1710 12TH AVE.

SDCI# 3036725-LU (3035745-EG)

DESIGN REVIEW BOARD RECOMMENDATION

7.28.2021

THE STREET EDGE - CHARACTER OF EXISTING CONTEXT

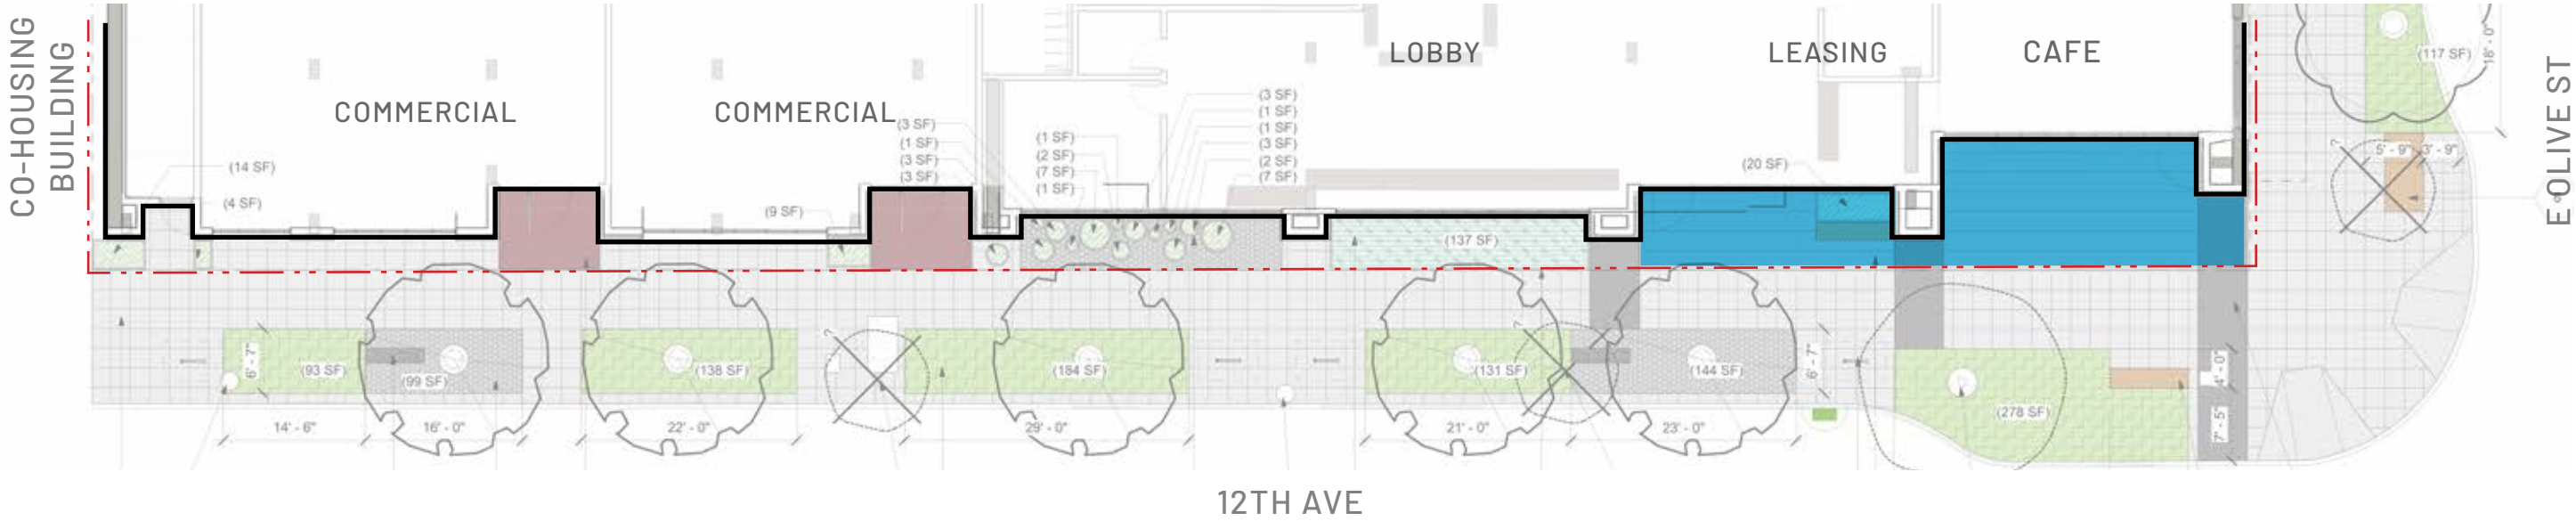
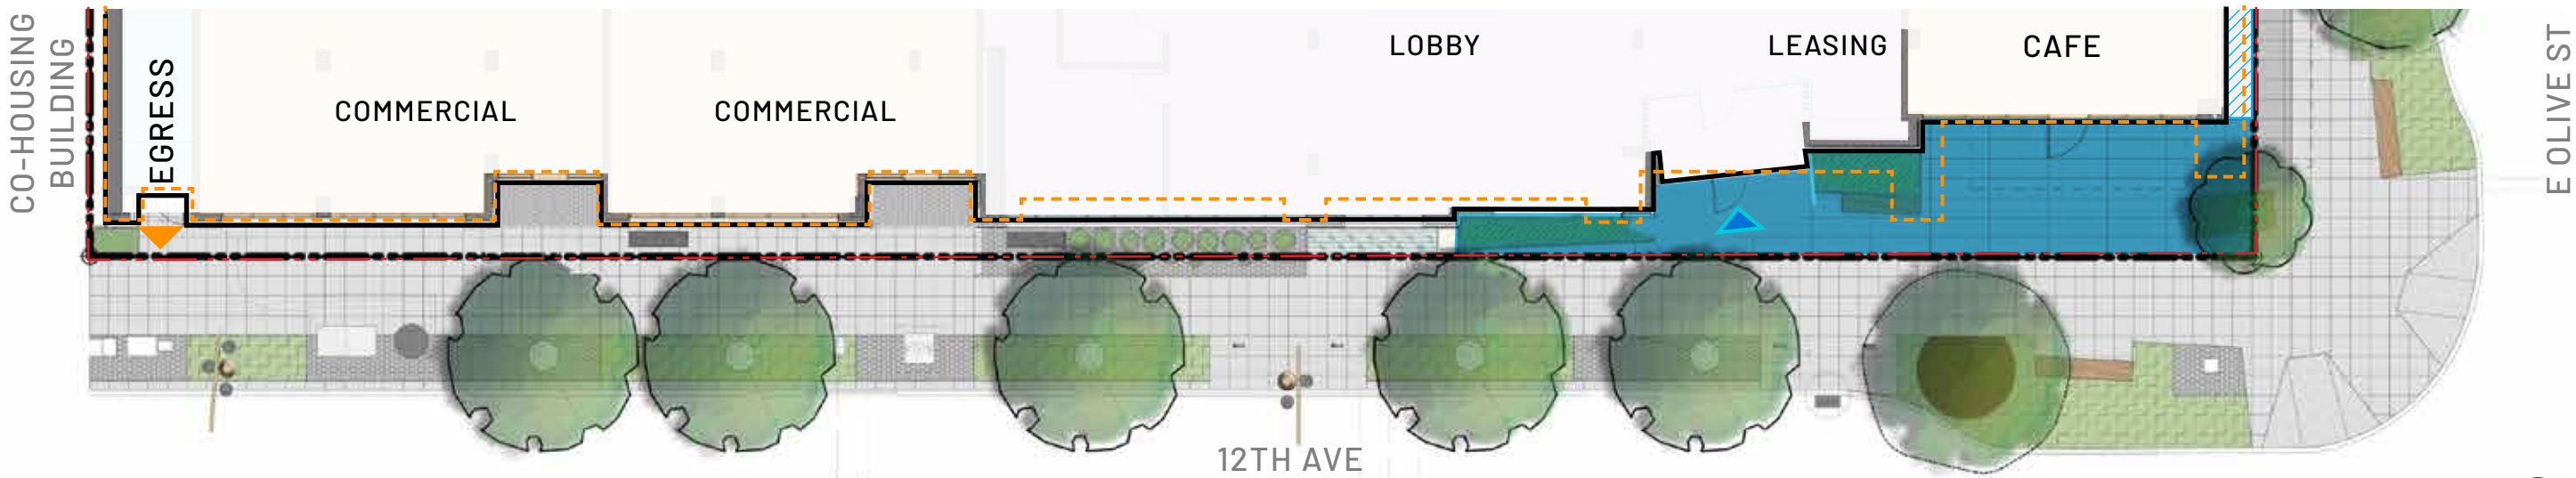
5.a **DRB GUIDANCE:** The Board expressed appreciation for the continued development of the street edge and recognized the intent to tie this development to existing context. The Board noted that the **uniformity of expression** in the current design however did not seem to reflect the character of existing context or the exhibits and analysis provided in the packet documenting that context. Similar to Staff guidance at EDG, the Board agreed these **street edge elements should be further broken down to provide greater variation in scale and expression** to better fit into context, and **encouraged the development of more outdoor space and seating areas.** (CS2-B, CS2-1, CS3-A, CS3-1, PL1, and PL3)

5.b **DRB GUIDANCE:** Echoing public comment, the Board noted the transitional character of this block, between the denser and more commercial fabric to the south and the more residential character to the north, noted that a careful calibration of these influences would be required and agreed that **porosity and activation of this edge** is critical for a successful design. (CS2-1.b, CS3-A, and PL3-C)

RESPONSE:
The adjustments to the overall massing have informed changes to the base, as noted above, create a variation in expression at grade [CS2-B-2 Connection to the Street / CS2-B-3 Character of Open Space]. This is further enhanced at the main corner with the brick extending up an additional floor. Also in how the brick is expressed (modern form) vs. to the north and east where the brick includes piers and more punched openings (more traditionally inspired) [CS2-1 Sense of Place - 12th Ave]. The lobby entry is emphasized with warm wood taken from the alley side gaskets, brought to grade and carried through the smaller gaskets at the retail entries [PL3-1 Entries]. For option C.2A - Angled, the angles are also brought to grade here [PL1 Enhancing Open Space]. The three commercial entries are expressed differently along with the brick with the two north alcove style entries picking up scale and language from shop and building entries to the north of the site and across the street. [CS3-A-1 Fitting old and new together]

Increased open area 180% and made less chopped up/separated but still transitioning to simpler, quite, traditional scale moving north.

THE STREET EDGE - POROSITY AND ACTIVATION

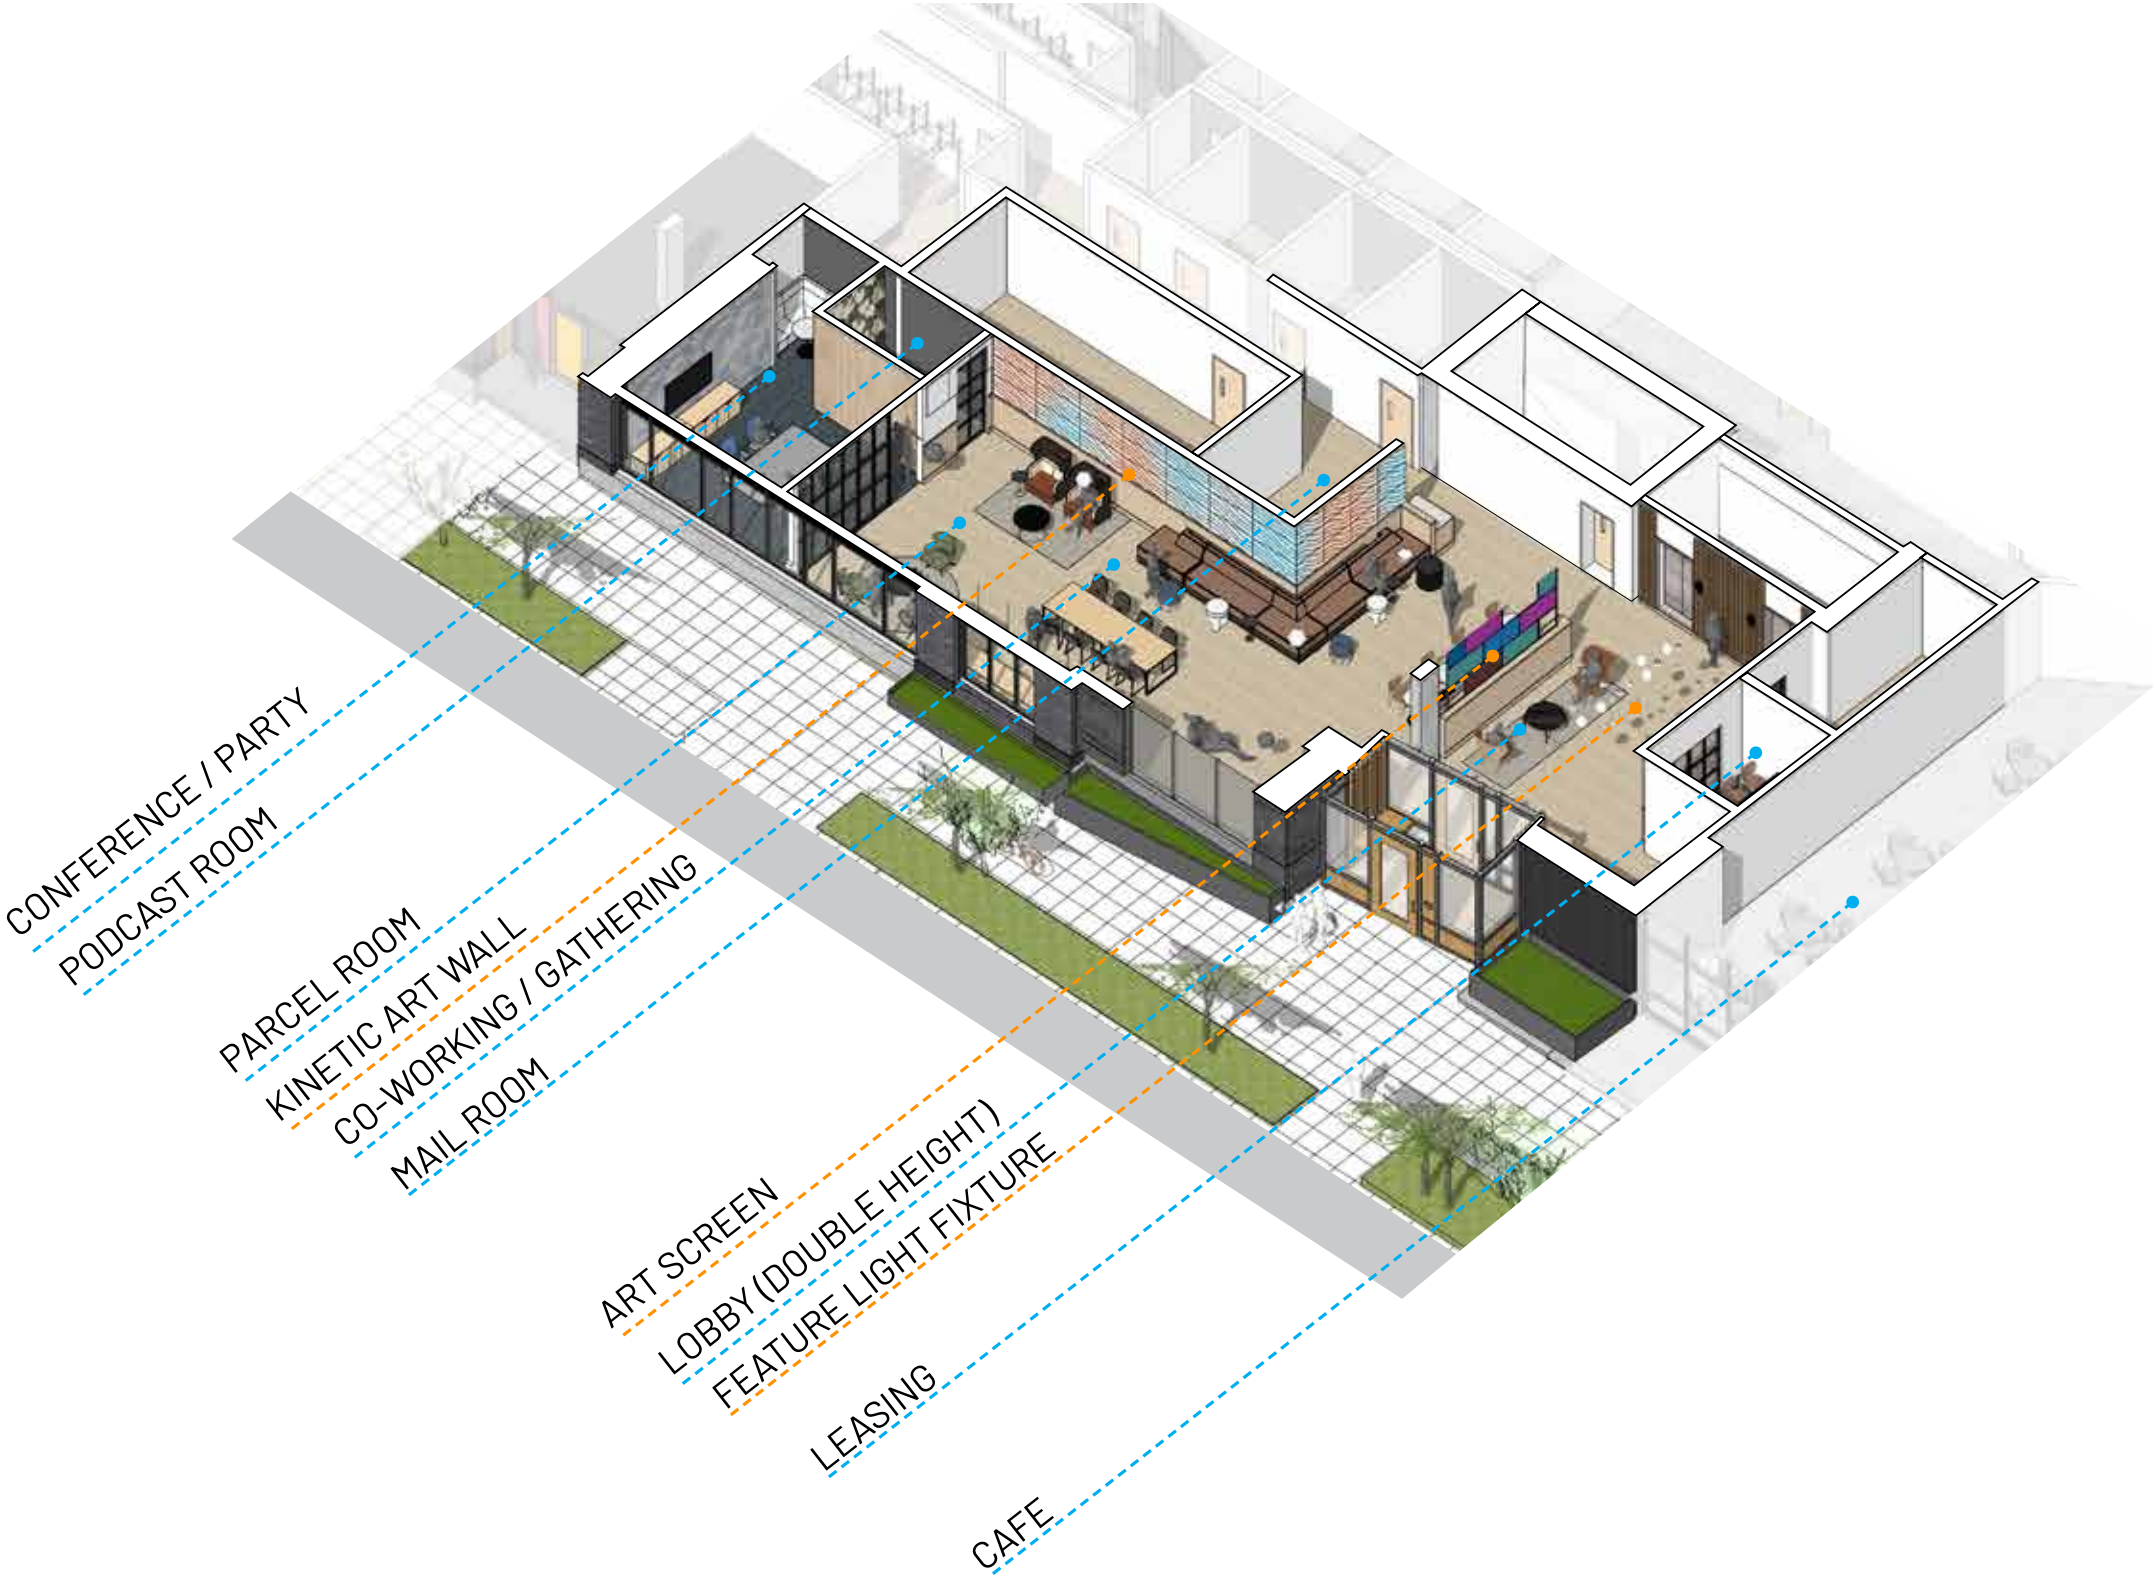
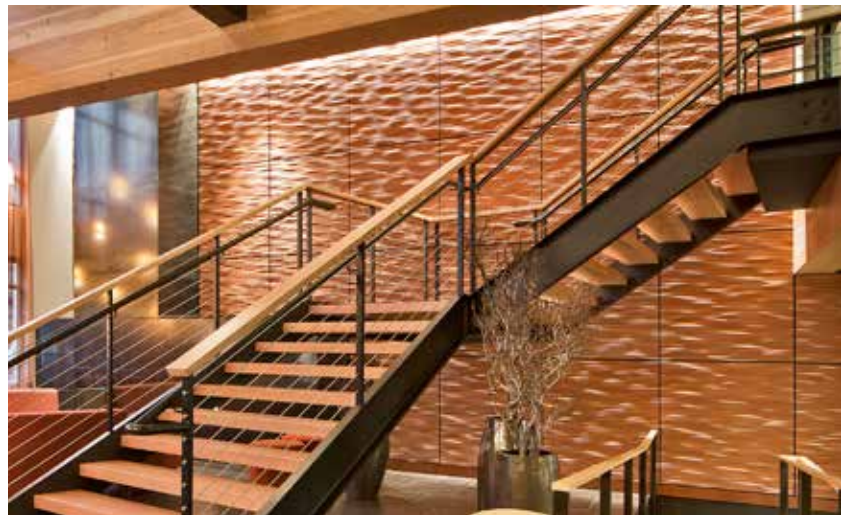
DRB GUIDANCE: The Board questioned the choice to allocate such a significant **length of the street frontage to residential amenity area**, but agreed that at this stage in the review process they would simply provide guidance to design and **program these areas in a manner that physically engages the street and generates activity**, offers **porosity and opportunities for human interaction**.(CS2 and PL3)

The theme of the building is balance between work and play/ day and night. As the workforce in this neighborhood moves more to remote work, there is a need for socialization. This is the only common indoor space and is located to facilitate collaboration at the entry of the building and where those using the space can directly interact with those in the public realm. During the day this is a brightly lit, cafe feeling space with plenty of options in seating, work tables, raised bar areas, more private rooms and open spaces each with windows to the sidewalk. The sense of action is enhanced with art, kinetic art wall, and lighting.

As the end of the work day blends into evening and Capitol Hill becomes a destination for evening entertainment and dining, the space changes attitude to host gatherings of friends headed out or just stopping by to hang out. The art and lighting shifts with the change of day, transforming the same space to a front porch where residents meet their neighbors and where passers by see ever changing art and cast of characters. [CS2-B-2 Connection to the Street] This character spills out onto the sidewalk at the open space created by the form of the building where there are benches incorporated into plantings that open to the cafe seating area on the corner [PL3-A-4 Ensemble of Elements / PL3-B-4 Interaction].
